## SB, 335XPT, Carburettor, 1999-02

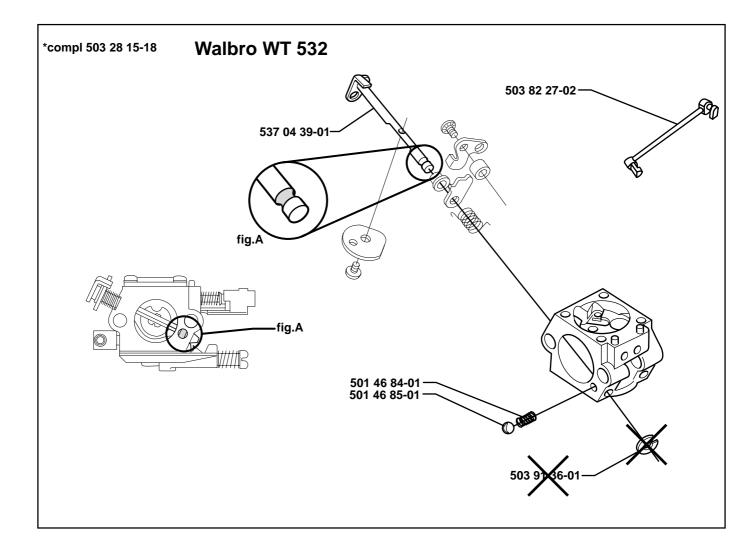
In order to ensure correct operation of the choke the choke shaft has been modified so that the valve is locked in the closed position by a ball and spring. The choke rod has also been modified for the new shaft, and in order to facilitate identification it is now white instead of black.

Old Walbro 459 B carburettors can be converted to the new specification as detailed below. Walbro 459 B carburettors that have already been converted to the new specification may be found on production saws from serial number 850 0001 onwards. These can easily be identified by checking whether the spring-loaded ball is countersunk. See diagram A!

NOTE! The original Walbro 459 B carburettor assembly can be replaced with the NEW Walbro WT 532 carburettor without any further modification, but the NEW choke rod must also be fitted.
